GRID CODE CONSULTATION H/04

Proposed Grid Code Modifications H/04 and SA/2004

National Grid Response to Issues Raised by Ofgem and SKM Report

**Proposed Grid Code Modifications H/04 and
SA/2004**

Figure 3

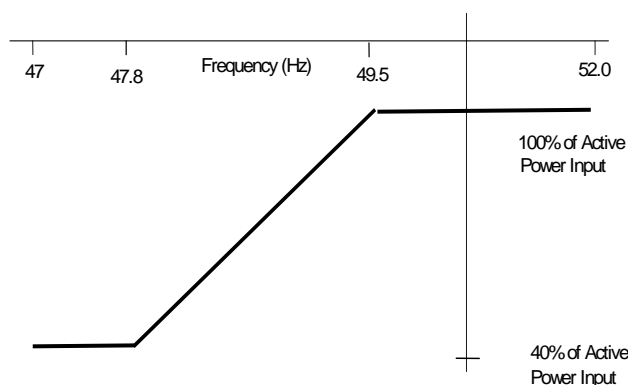
CC.6.3.3 (d) could be amended to read as follows.

CC.6.3.3 (d) A **DC Converter Station** must be capable of maintaining its **Active Power** input (i.e. when operating in a mode analogous to **Demand**) from the **GB Transmission System** (or **User System** in the case of an **Embedded DC Converter Station**) at a level not greater than the figure determined by the linear relationship shown in Figure 3 for **System Frequency** changes within the range 49.5 to 47 Hz, such that if the **System Frequency** drops to 47.8 Hz the **Active Power** input decreases by more than 60%.

Figure 5

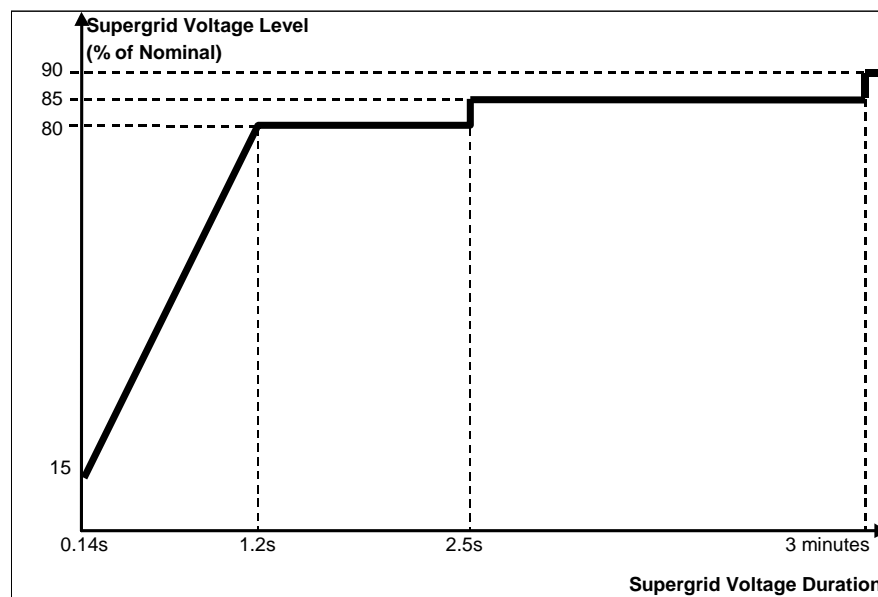
SKM recommended that the drafting of the Fault Ride Through paragraphs [CC.6.3.15(a) & CC.6.3.15(b)] should be revised as the requirements and application to classes of user was still unclear. National Grid accept that an alternative to the proposed wording might be considered to improve clarity. The revised drafting below reflects the intentions of the SA2004 and H/04 consultation reports.

SKM recommended that the drafting of CC.6.3.15(b)(ii) should be revised to remove ambiguity between “proportional to” and “within 1 second”. National Grid believes that the intended application was clear in the reports SA2004 and H/04. However the alternative drafting below addresses the SKM recommendation by dividing the paragraph into the provision of power during the voltage dip and the recovery of active power after the voltage has returned to the minimum normal range.

SKM suggested that the relaxation against fault ride through under high wind speed shutdown conditions in CC.6.3.15(c)(i) is not supportable and should be removed. Whilst National Grid accepts the recommendation we believe that some users may see this as a tightening of the requirement on wind farm developers. However if the change suggested by SKM was made by Ofgem the paragraph CC.6.3.15(c)(i) would appear as shown in Option 2 below.

SKM noted that CC.6.3.15(a)(ii) requires immediate power recovery after a fault cleared in normal clearance times whilst CC.6.3.15(b)(ii) requires power recovery within 1 second and considered that the former is unreasonable for some new generation technologies. The difference is due to the fact that the former deals with normal system fault clearance, events that occurs several hundred times a year while the latter is drafted to provide a resilient and robust system for relatively rare but prolonged voltage depression events.

National Grid accepts that the word “immediate” does not in reality need to correspond with instantaneous and that a few hundred milliseconds would be acceptable as supported by studies. Studies with these time delays show negligible impact on system stability and security under normal operating conditions. Therefore, National Grid agree to change the drafting to allow an explicit short time delay of 0.5 seconds.

demand disconnection and the potential for restricting the siting of wind farm connections. Studies have shown that relatively small reductions in power spread over a number of wind farms will have a significant detrimental impact on system frequency control and stability. If Ofgem requires NGC to maintain current statutory standards of frequency control and stability, an increase in frequency response holdings and hence in system balancing costs would be required. Incorporating the SKM suggestion using 0.5 seconds as the delay would give the text shown in Option 3 below.

The SKM Report questions the appropriateness of the requirement for proportionality of active power during the voltage dip to the reduced Supergrid Voltage for all generators. The report goes on to state that the voltage in lower voltage networks will also be depressed when the Supergrid is subject to voltage dips and that the requirement could therefore be more onerous on embedded generators. National Grid agrees that the voltage is usually higher in distribution networks where embedded generation is connected due to the presence of the power station and the impedance to the source of the voltage depression. National Grid would accept a change to make the Active Power provision of embedded generation proportional to the local voltage at the distribution system entry point. The suggested revision would result in the text shown in Option 4 below.

- (i) remain transiently stable and connected to the **System** without tripping of any **Generating Unit** or **Power Park Module** and / or any constituent element, for balanced **Supergrid Voltage** dips and associated durations anywhere on or above the heavy black line shown in Figure 5. Appendix 4 and Figures CC.A.4.3 (a), (b) and (c) provide an explanation and illustrations of Figure 5; and,

- (ii) provide **Active Power** output, during **Supergrid Voltage** dips as described in Figure 5, at least in proportion to the retained balanced **Supergrid Voltage** and shall generate maximum reactive current without exceeding the transient rating limits of the **Generating Unit** or **Power Park Module** and any constituent element; and,
- (iii) restore **Active Power** output, following **Supergrid Voltage** dips as described in Figure 5, within 1 second of restoration of the **Supergrid Voltage** to the minimum levels specified in

CC.6.1.4, to at least 90% of the level available immediately before the occurrence of the dip except in the case of a **Non-Synchronous Generating Unit** or **Power Park Module** where there has been a reduction in the **Intermittent Power Source** in the time range in Figure 5 that restricts the **Active Power** output below this level.

- (ii) provide **Active Power** output, during **Supergrid Voltage** dips as described in Figure 5, at least in proportion to the retained balanced **Supergrid Voltage** (or the retained balanced voltage at the **User System Entry Point** if **Embedded**) and shall generate maximum reactive current without exceeding the transient rating limits of the **Generating Unit** or **Power Park Module** and any constituent element; and,

- (iii) restore **Active Power** output, following **Supergrid Voltage** dips as described in Figure 5, within 1 second of restoration of the **Supergrid Voltage** to the minimum levels specified in CC.6.1.4 (or within 1 second of restoration of the voltage at the **User System Entry Point** to 90% of nominal or greater if **Embedded**), to at least 90% of the level available immediately before the occurrence of the dip except in the case of a **Non-Synchronous Generating Unit** or **Power Park Module** where there has been a reduction in the **Intermittent**

Figure CC.A.4.1 (a)

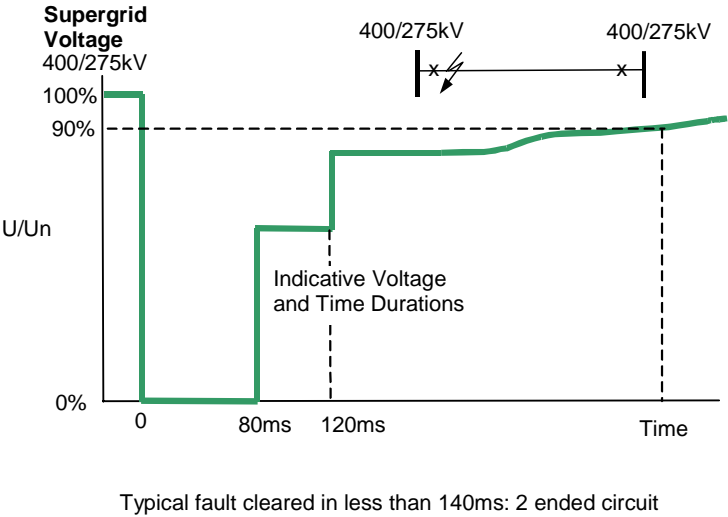
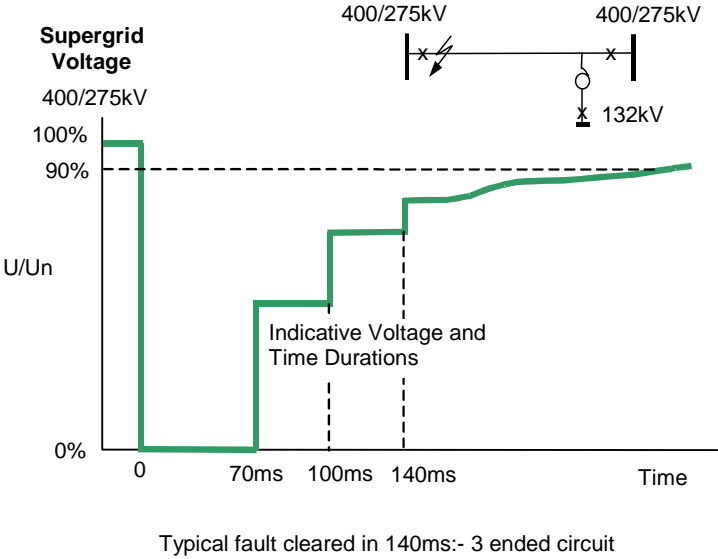
SKM proposed that the illustrative figures in CC.A.4.2 be revised by removal of vertical arrows and addition of 400/275kV to the labels on the vertical axes. National Grid agrees and the revised the diagrams would appear as follows.
